THE GLIDING FEDERATION OF AUSTRALIA

AD 417

AIRWORTHINESS DIRECTIVE

- TYPE AFFECTED:** All Gliders fitted with TOP add on engines.
- SUBJECT:** Inspection for cracks in the engine frame and replacement of the connecting rod bearing cages and needles.

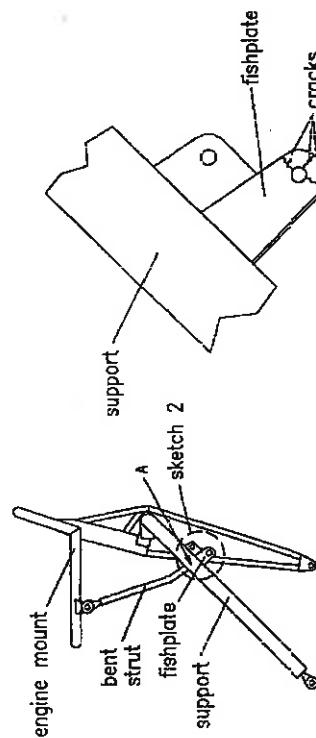
Some fishplates at the support of the TOP-engine pod showed cracks, which could cause the failure of these fishplates. In this case engine and propeller would not be guided correctly.

The fishplate at the support (A-shaped part of the frame) must not show any cracks. For inspection clean the fishplates with a dry rag and look for cracks (see sketches 1 and 2). Cracks have to be repaired according to Action 3. If there are not any, only Action 2 is necessary.

The bent struts must not be pressed against the support at position A (see sketch 1). The rod ends of the bent strut make it possible to turn the strut slightly, while the distance between support and strut changes. When the strut is turned away distance must be at least 0,3 mm. The lower fixing screws of the bent struts have to be 22 mm long (M6x22).

Otherwise these screws, by which the struts are fastened to the support, must be detached and replaced by new screws and brass collars according to sketch 3. Never open the counter nuts of the rod ends, adjusting a rotated rod end would be very difficult.
